SUBJECT: R.E. GINNA NUCLEAR POWER PLANT - STAFF ASSESSMENT OF INFORMATION PROVIDED PURSUANT TO TITLE 10 OF THE *CODE OF FEDERAL REGULATIONS* PART 50, SECTION 50.54(f), SEISMIC HAZARD REEVALUATIONS FOR RECOMMENDATION 2.1 OF THE NEAR-TERM TASK FORCE REVIEW OF INSIGHTS FROM THE FUKUSHIMA DAI-ICHI ACCIDENT (TAC NO. MF3972)

STAFF ASSESSMENT BY THE OFFICE OF NUCLEAR REACTOR REGULATION

RELATED TO SEISMIC HAZARD AND SCREENING REPORT

R.E. GINNA NUCLEAR POWER PLANT

Figure 3.3-1 Plot of Staff's and Licensee's Base Case Shear-Wave Velocity Profiles for the Ginna site

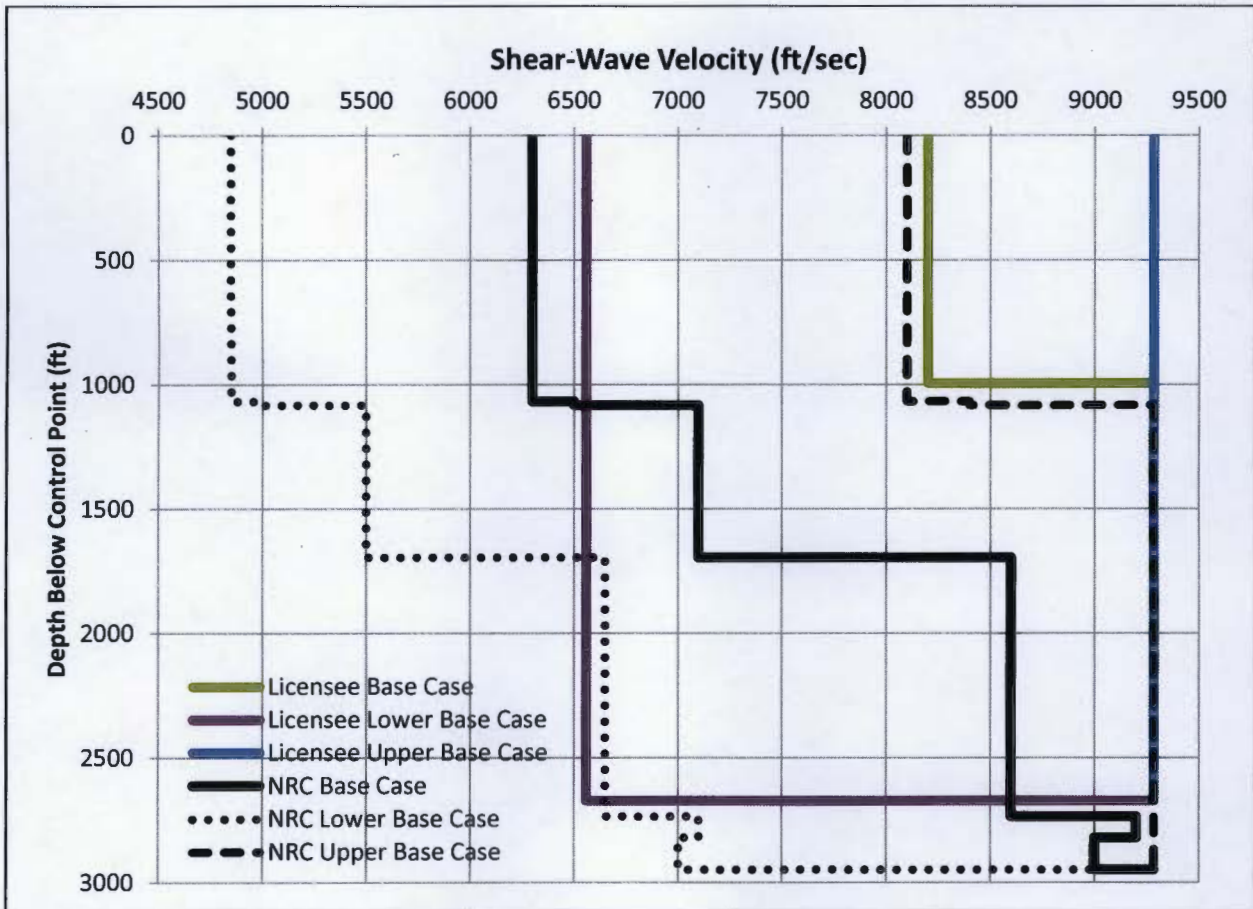
To characterize the subsurface geology, the licensee developed three site base case profiles. The middle, or best estimate, profile was developed using measured and assumed compressional wave velocities and assumed Poisson's ratios (a ratio of the compressional wave to shear wave velocity). The licensee developed upper and lower base case profiles using a natural log standard deviation of 0.2 and limited the upper base case velocity to 9,285 ft/s (2,800

m/s), the velocity of hard rock. Figure 3.3-1 of this assessment shows the licensee's three shear-wave velocity base case profiles.

Because many of the same geologic units underlie both the Ginna and the Nine Mile Point sites, the staff used geophysical measurements from the Nine Mile Point, Unit 3 SAR for these common geologic units. The staff used these velocity data along with information about the thickness of geologic units from deep well data to develop the middle, or best estimate, base case velocity profile. Geologic evidence at the nearby borehole indicated approximately 2950 ft of sedimentary rock overlying the Precambrian basement (Kreidler et al., 1973). Because the site lacks specific data about layer thicknesses and seismic velocities, the staff used Appendix B of the SPID to generate upper and lower base case profiles using a natural log standard deviation of 0.2. To capture the uncertainty in the depth to base rock, the staff used a value of ± 150 ft (± 46 m), which is consistent with the more recent investigations for Nine Mile Point and considerably less than the ± 802 ft (± 245 m) depth used by the licensee. Figure 3.3-1 of this assessment shows the velocity profiles developed by the staff compared with those developed by the licensee. Estimates of shear-wave velocity and profile thickness determined by the staff differ somewhat from those developed by the licensee. However, as described below, these differences do not significantly impact the final hazard results.

Figure 3.3-2 Plot Comparing the Staff's and the License's Median Amplification Functions and Uncertainties for the Ginna site

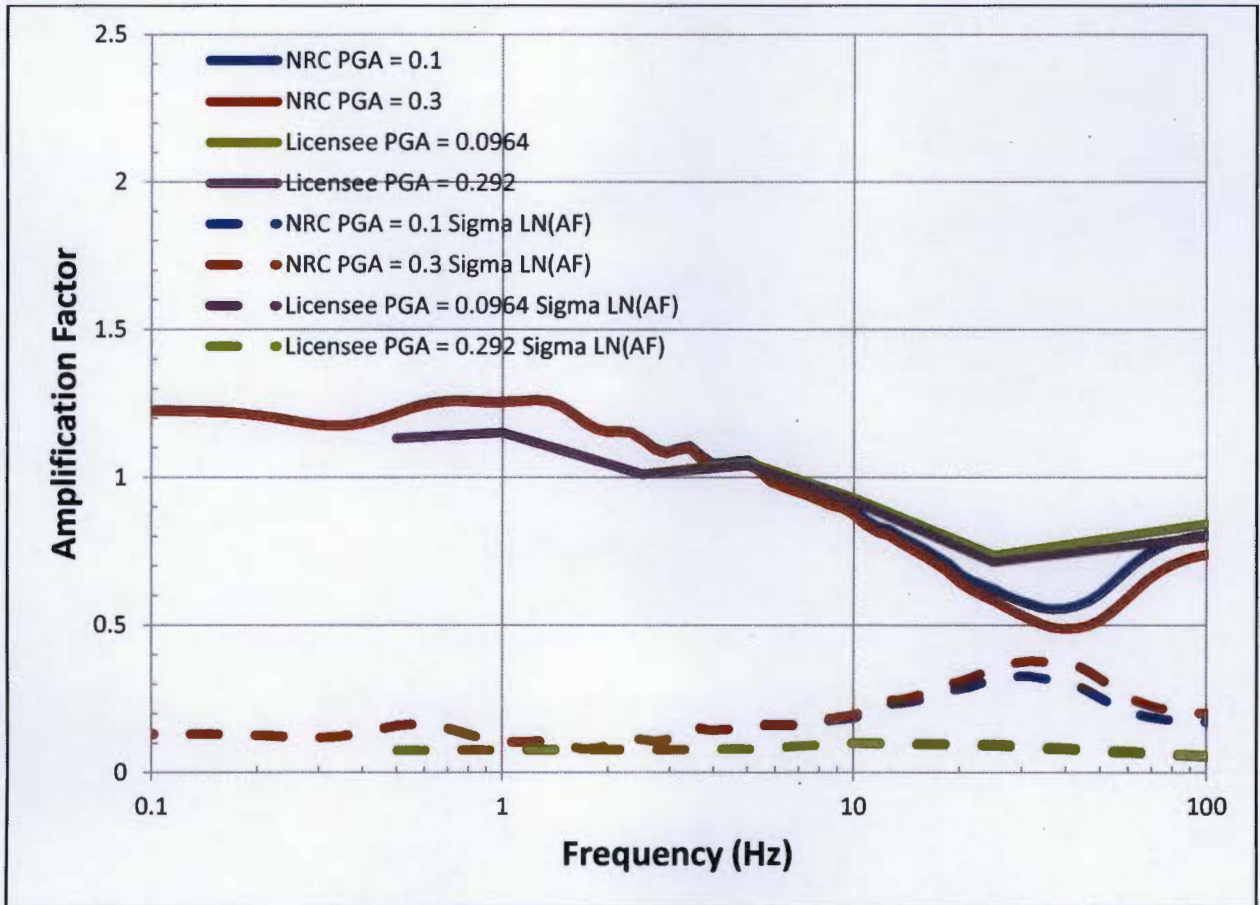
To determine the value of kappa, the staff used the low strain damping values, shear wave velocities, and layer thicknesses for each layer to arrive at values of 0.016, 0.018, and 0.009 sec for the best-estimate, lower, and upper velocity profiles, respectively. These three kappa values include the 0.006 sec contribution from the hard rock. To further model the uncertainty in the kappa value, the staff used a natural log standard deviation of 0.35 to calculate lower and upper values of kappa for each profile. This approach resulted in nine kappa values, which range from 0.006 to 0.029 sec. The staff applied this approach to account for the large uncertainties

associated with estimating kappa for the Ginna site, for which limited subsurface data were collected. The staff gave the best-estimate kappa values for each profile a weight of 40 percent and the upper and lower kappa values a weight of 30 percent each in the site response analysis. Figure 3.3-2 of this assessment shows a comparison of the staff's and the licensee's median site amplification functions and uncertainties (± 1 standard deviation) for two of the eleven input loading levels. The NRC staff's and licensee's amplification functions are generally similar in shape and amplitude. Amplification functions determined by the staff are slightly higher than those developed by the licensee for frequencies between 0.2 and 5 Hz. However, as shown in Figure 3.3-3 of this assessment, these differences in site response analysis do not have a large impact on the control point seismic hazard curves, or the resulting GMRS, as discussed below. Appendix B of the SPID provides guidance for performing site response analyses, including capturing the uncertainty for sites with less subsurface data; however, the guidance is neither prescriptive nor comprehensive. As such, various approaches in performing site response analyses, including the modeling of uncertainty, are acceptable for this application.

Figure 3.3-3 Plot Comparing the Staff's and the Licensee's Mean Control Point Hazard Curves at a Variety of Frequencies for the Ginna site

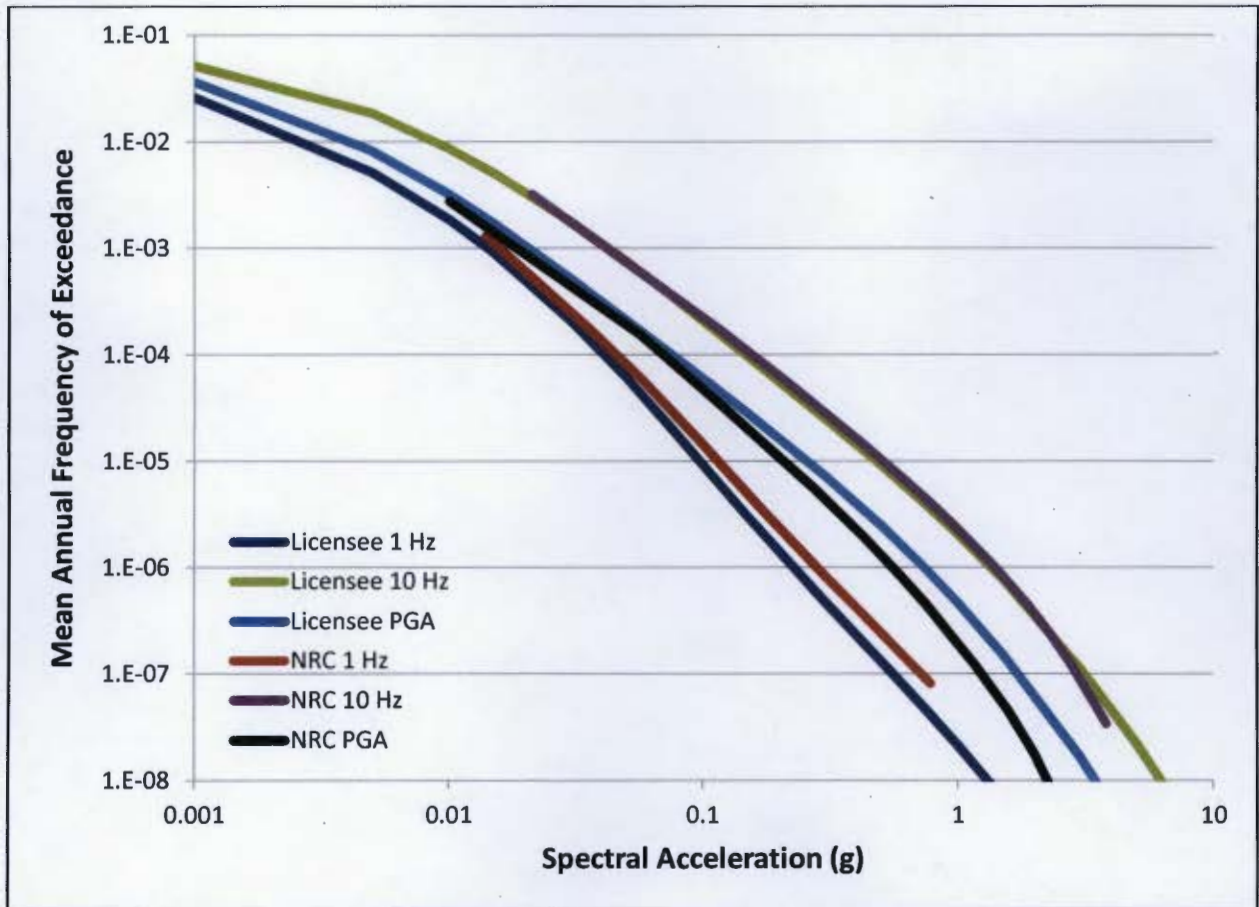
In summary, the staff concludes that the licensee's site response analysis was conducted using present-day guidance and methodology, including the NRC-endorsed SPID. The NRC staff performed independent calculations which confirm that the licensee's amplification factors and control point hazard curves adequately characterize the site response, including the uncertainty associated with the subsurface material properties, for the Ginna site.

Figure 3.4-1 Comparison of the Staff's GMRS with Licensee's GMRS and the Ginna SSE

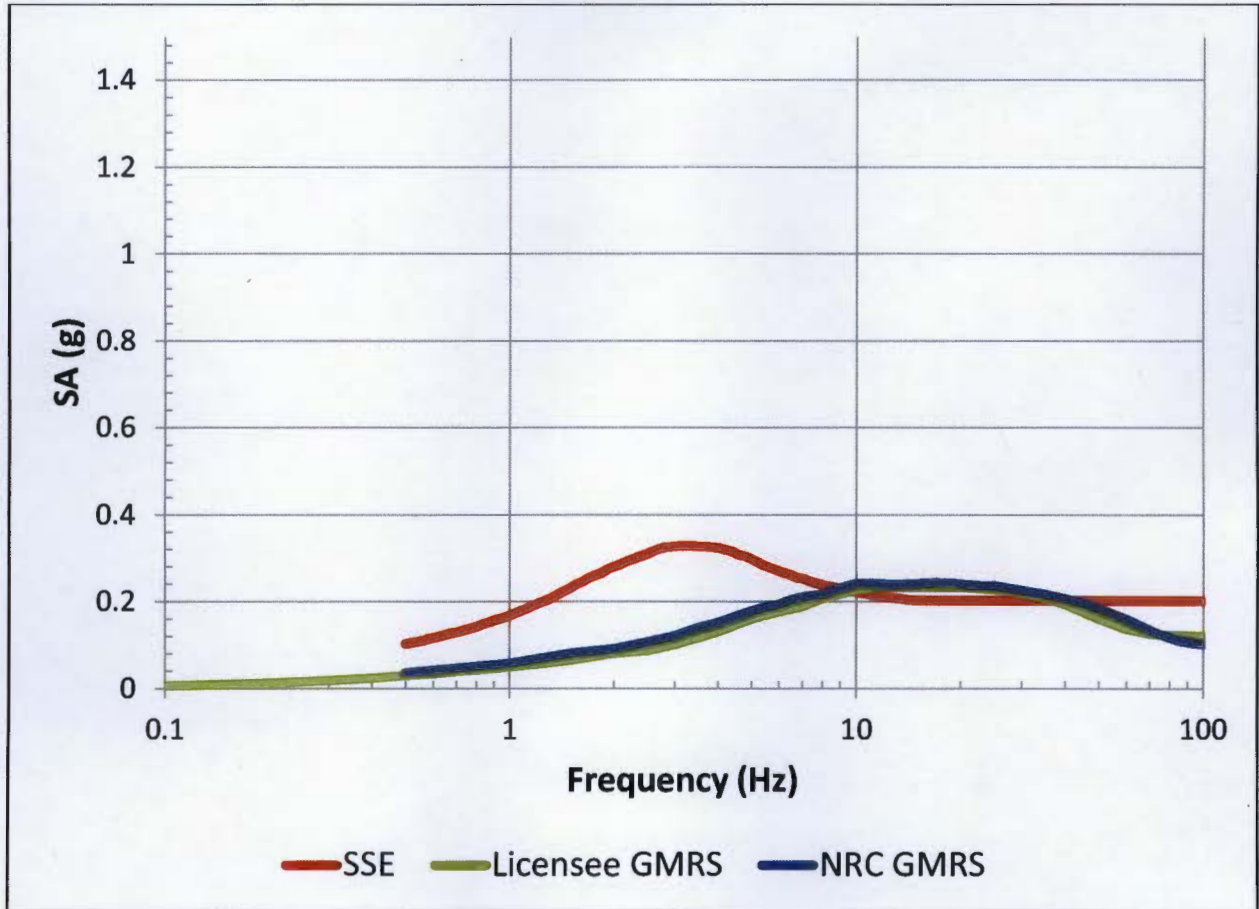
The NRC staff independently calculated 10^{-4} and 10^{-5} UHRS using the results of its confirmatory PSHA and site response calculations described in Sections 3.2 and 3.3 of this staff assessment, respectively. Figure 3.4-1 of this assessment shows a comparison of the GMRS determined by the licensee to that determined by the staff.

As shown in Figures 3.4-1 of this assessment, the NRC staff's GMRS is very similar to the licensee's in both amplitude and shape. The NRC staff confirms that the licensee used the present-day guidance and methodology outlined in RG 1.208 and the SPID to calculate the horizontal GMRS, as requested in the 50.54(f) letter. As such, the NRC staff concludes that the GMRS determined by the licensee adequately characterizes the reevaluated hazard for the Ginna site. Therefore, this GMRS is suitable for use in subsequent evaluations and conformations, as needed, for the response to the 50.54(f) letter. The NRC staff performed both a PSHA and site response confirmatory analysis and achieved results consistent with the licensee's horizontal GMRS.

In reaching this determination, the NRC staff confirmed the licensee's conclusion that the licensee's GMRS for the Ginna site is bounded by the SSE for Ginna in the 1 to 10 Hz range, except for a narrow band exceedance between 9 and 10 Hz. The staff also confirmed the licensee's conclusion that the GMRS exceeds the SSE for Ginna above 10 Hz. As such, a seismic risk evaluation and SFP evaluation are not merited and a high-frequency confirmation is merited in accordance with the SPID criteria. The NRC review and acceptance of Exelon's high-frequency confirmation (i.e., Item (4)) will complete the Seismic Hazard Evaluation identified in Enclosure 1 of the 50.54(f) letter, for Ginna.
